TOWNSHIP OF FRANKLIN
Board of Adjustment
Agenda
Thursday, March 5, 2026

UKRAINIAN ORTHODOX CHURCH OF U.S.A / ZBA-25-00008

UKRAINIAN ORTHODOX CHURCH OF U.S.A / ZBA-25-00007

SYRACUSE 1950 EASTON AVENUE OWNER LLC / ZBA-25-00009

Figure 2: FEMA Special Flood Hazard Area along stream and in roadway

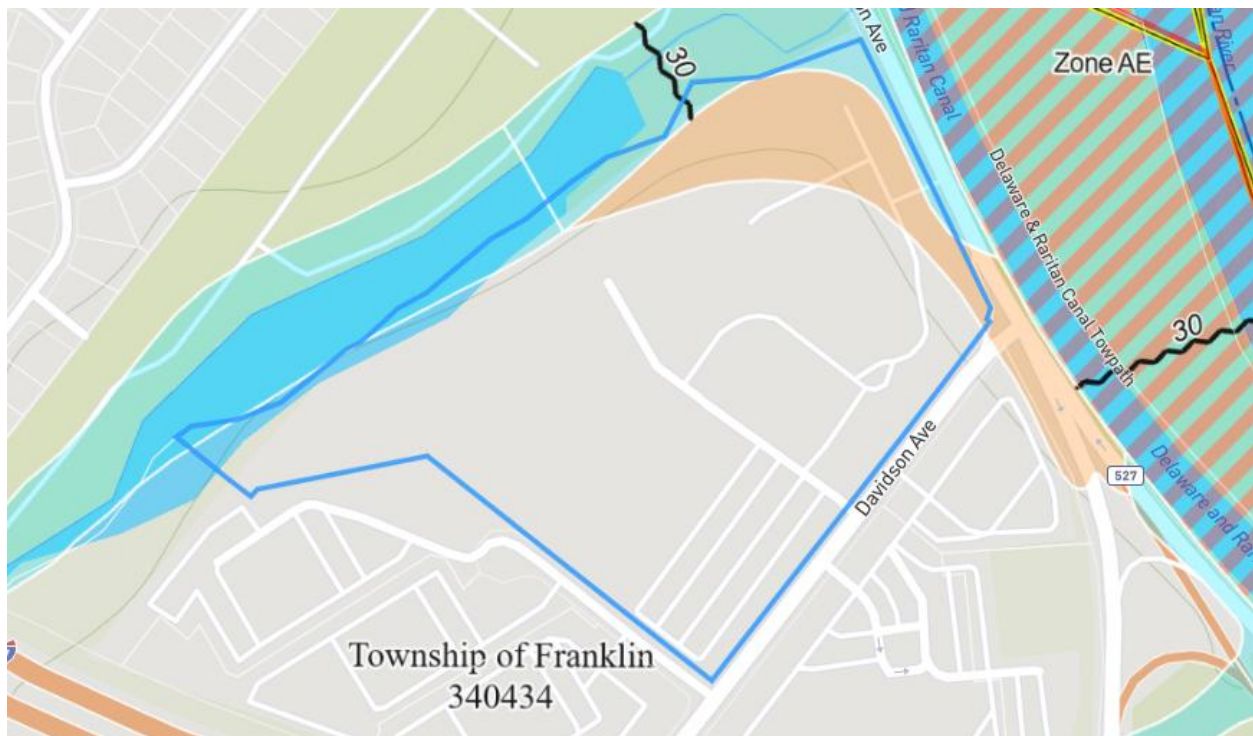
- FEMA records show a Special Flood Hazard Area on a portion of the property.
- GIS information provided by the NJDEP indicates that wetland areas may exist on a portion of the property.
- The applicant is proposing to subdivide the property into two lots, fully conforming in size and all bulk requirement for the zone. A variance is required for expansion of a non-conforming use; the church and cultural center are preexisting non-conforming uses in the B-I Zone.
- It is presumed that the applicant is proposing to perfect the minor subdivision by deed filing with the County.

Figure 5: Proposed Subdivision (ZBA-25-00008)

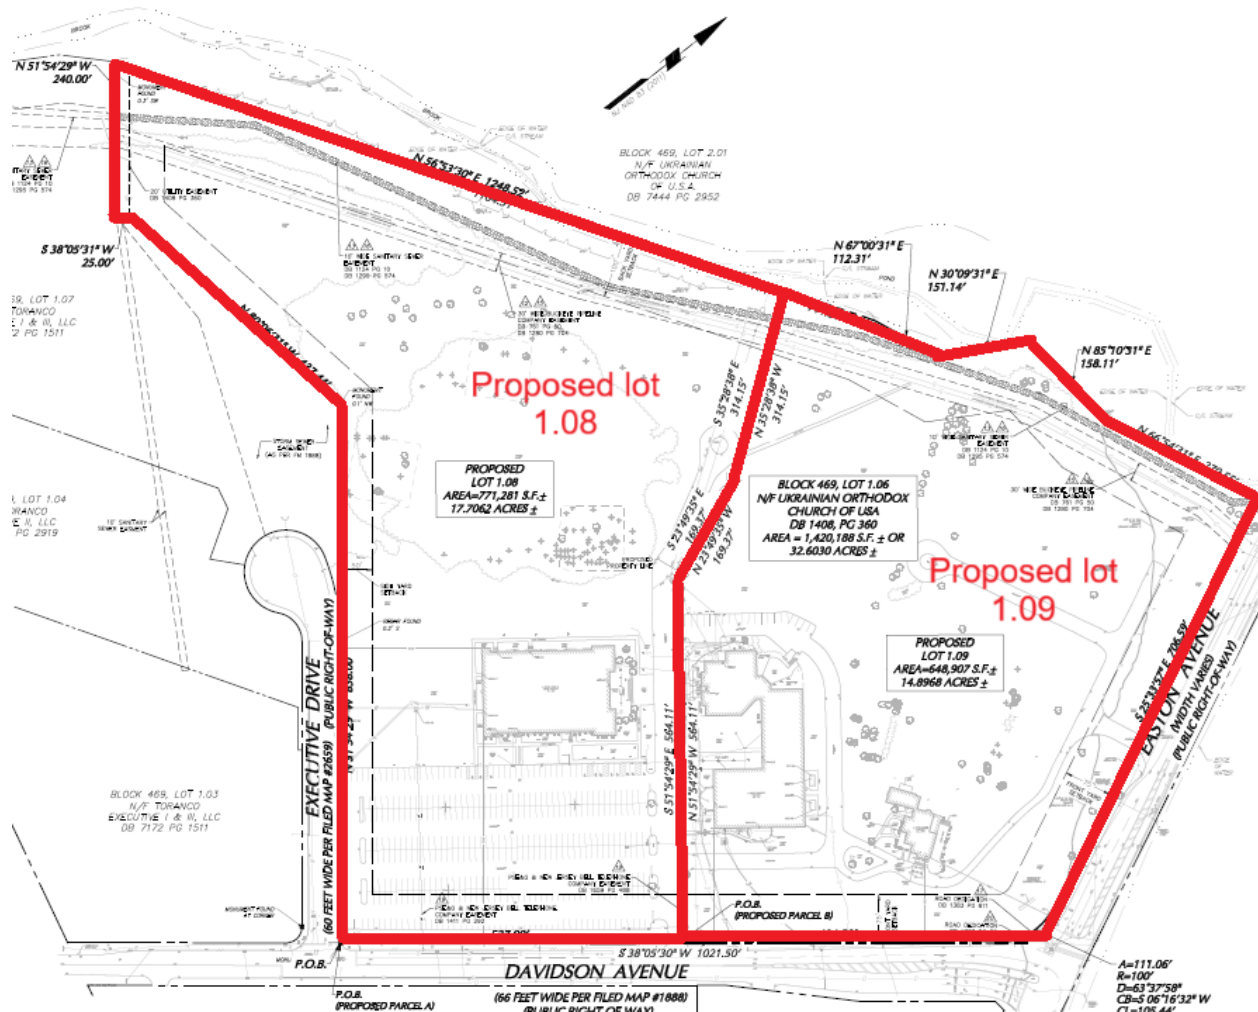
1. The proposed subdivision plan reflects two proposed lots that significantly exceed minimal lot area and frontage requirements and comply with all applicable bulk requirements based on the existing facilities on the site. No bulk variances are required.
2. The application should address necessary coordination between the two proposed lots both with and without the proposed construction reflected on the site plans. This would include, as necessary, easements related to parking, access, utilities and/or drainage.
